TRANS/WP.29/GRRF/2003/11
22 November 2002

PROPOSAL FOR DRAFT AMENDMENT TO REGULATION No. 13
(Braking)

Transmitted by the Expert from the Russian Federation

Views of the expert from the Russian Federation regarding the requirements for an auxiliary spring chamber release system (Regulation No. 13, annex 8, para. 3)

Figure 1

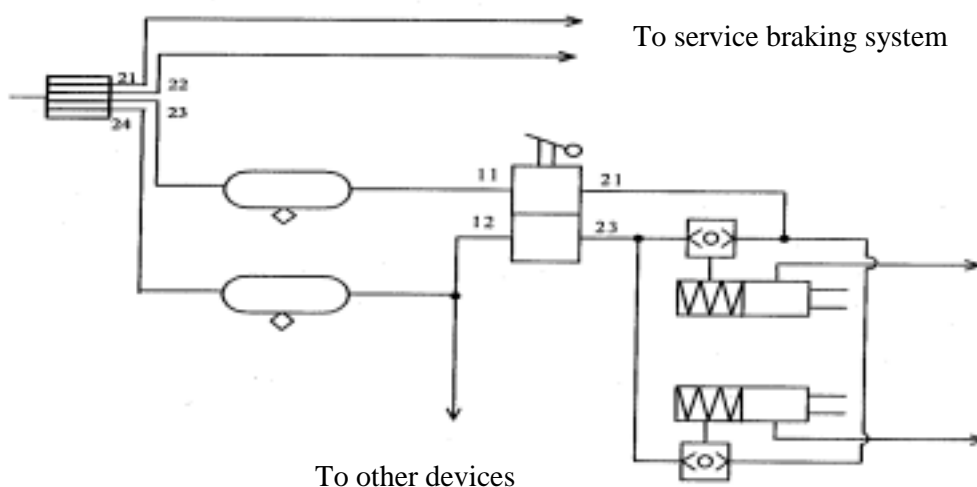
The auxiliary spring compression chamber release systems in buses employ designs with a manually operated combination valve. In these systems the main valve, designed for the proportional control of the spring compression chambers, is combined with the supplementary valve of the auxiliary release system (Wabco 961 722 2620 ... 2640). The main and the supplementary valves have the same control. This feed-line arrangement is shown in figure 1.

When pressure in the vehicle's pneumatic system is being increased from zero, this arrangement is in conformity with the requirements of paragraph 2.3, as the reservoirs of the service braking system are filled first. In all other cases, the spring compression chambers can release even when there is zero pressure in the service braking system reservoirs, which is not in line with the requirements of paragraph 2.3. (part 2).

Accordingly, in the arrangement set out in figure 1, the spring brake actuation system is not in line with paragraph 2.3. To resolve this problem, separate controls will have to be installed for the parking system and the auxiliary release system, as in figure 2.
